City of El Paso – City Plan Commission Staff Report

Case No: SUSU12-00022 Mission Ridge Unit Nine
Application Type: Major Final
CPC Hearing Date: April 5, 2012
Staff Planner: Justin Bass, 915-541-4930, bassjd@elpasotexas.gov
Location: North of Eastlake Boulevard and East of I-10
Legal Description Acreage: 53.82 acres
Rep District: ETJ
Existing Use: Vacant
Existing Zoning: N/A
Proposed Zoning: N/A
Nearest School: Horizon Heights Elementary School (0.23-mile)
Nearest Park: Ranchos Del Sol (4.80 miles)
Note: Emerald Pass Commercial Unit One, which includes a 3.15-acre park/pond lot, is located 0.10-mile south of this subdivision.
Parkland Fees Required: N/A
Impact Fee Area: Not in Impact Fee Area and will not be subject to impact fees
Property Owner: State of Texas GLO
Applicant: Hunt Mission Ridge, LLC
Representative: CEA Group

ATTACHMENT 3

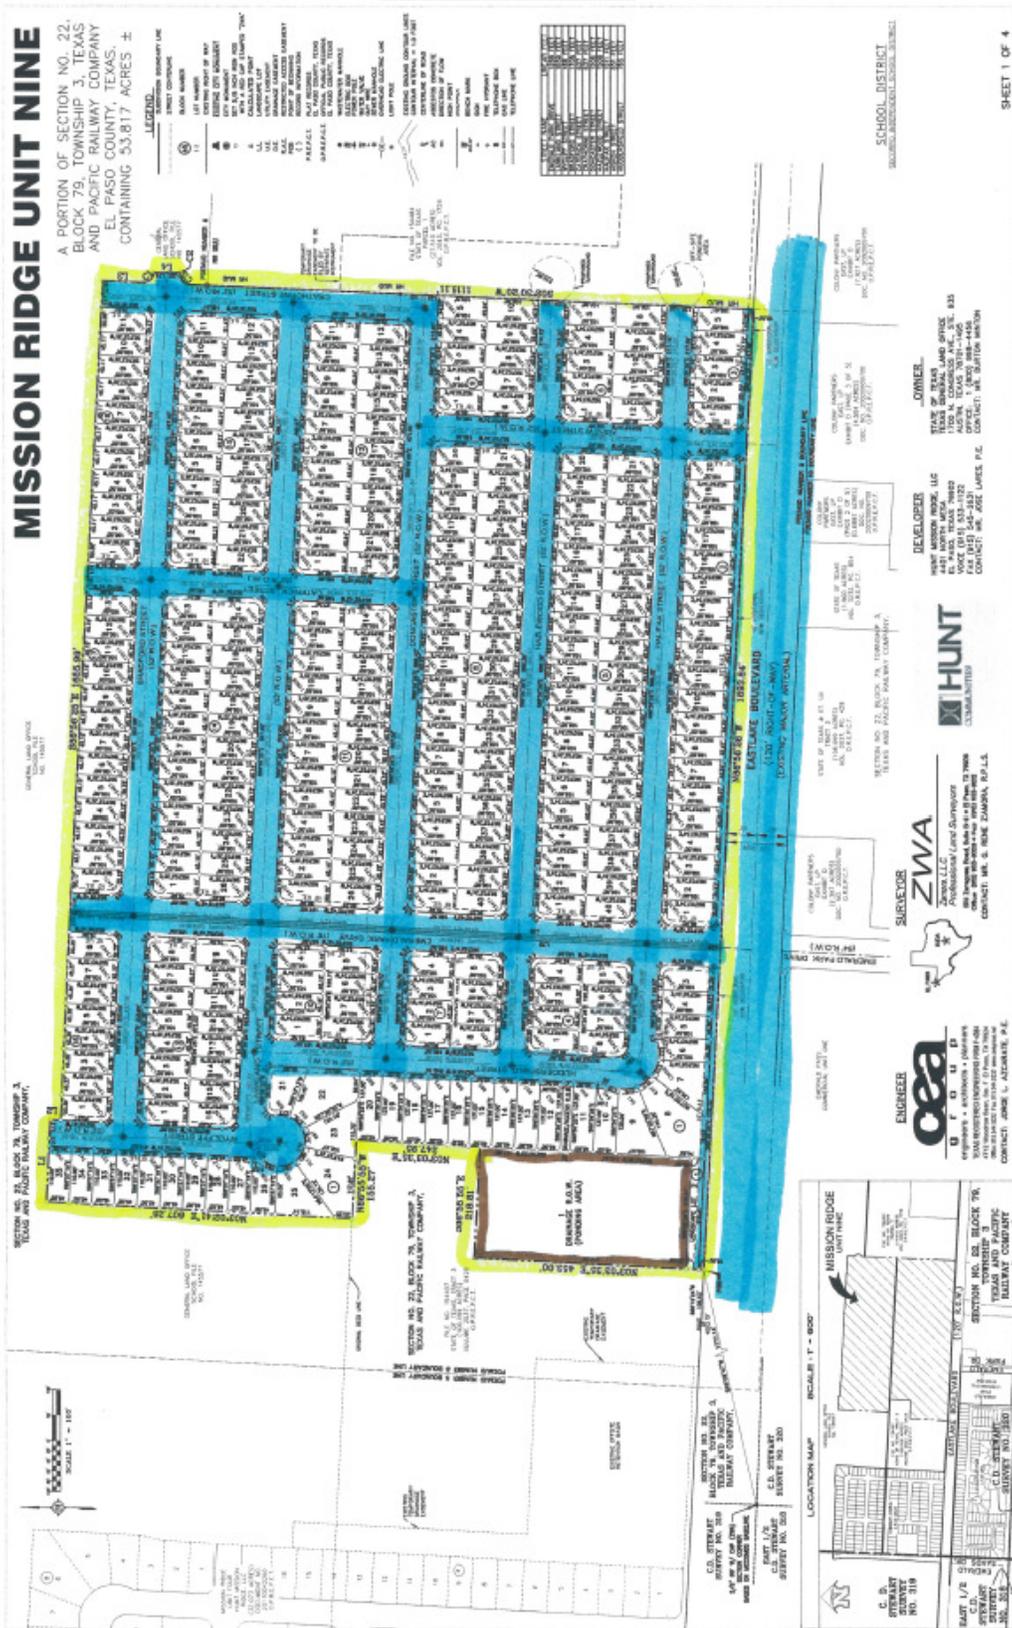
1. Provide Preparation Date On the Final Plat.

1. Per the TIA, the applicant is responsible for traffic mitigation and improvements at the intersection of Eastlake and Emerald Park. Such mitigation and improvements shall be coordinated with the approved by the County of El Paso.
2. Double frontage lots along Eastlake Boulevard shall comply with Section 19.16.080.D (Double Frontage Lots).
3. Landscape, vegetation to include trees, and irrigation systems are to be provided within the proposed medians on Emerald Park Drive.
4. The subdivision improvement plans are under review in accordance with Section 19.04.040 (Criteria for Approval) of the current subdivision ordinance. The final subdivision plat approval is still subject to the City Manager's determination that the Subdivision Improvement plans comply with this and other City ordinances.

1. At the improvement plan stage EPWU requires the Engineer to account for sediment volume in all calculations used to size stormwater drainage structures. Provide appropriate stormwater infrastructure to prevent sediment from clogging the proposed crossings.
2. The proposed ponding area shall meet subdivision ordinance requirements for a retention basin.
3. At the improvement plan stage provide improvements to protect the subject property from stormwater runoff from the undeveloped terrain.
4. EPWU recommends using principles of low impact development (such as recessed landscaping, rainwater harvesting, and porous pavements) to reduce the amount of developed stormwater runoff.
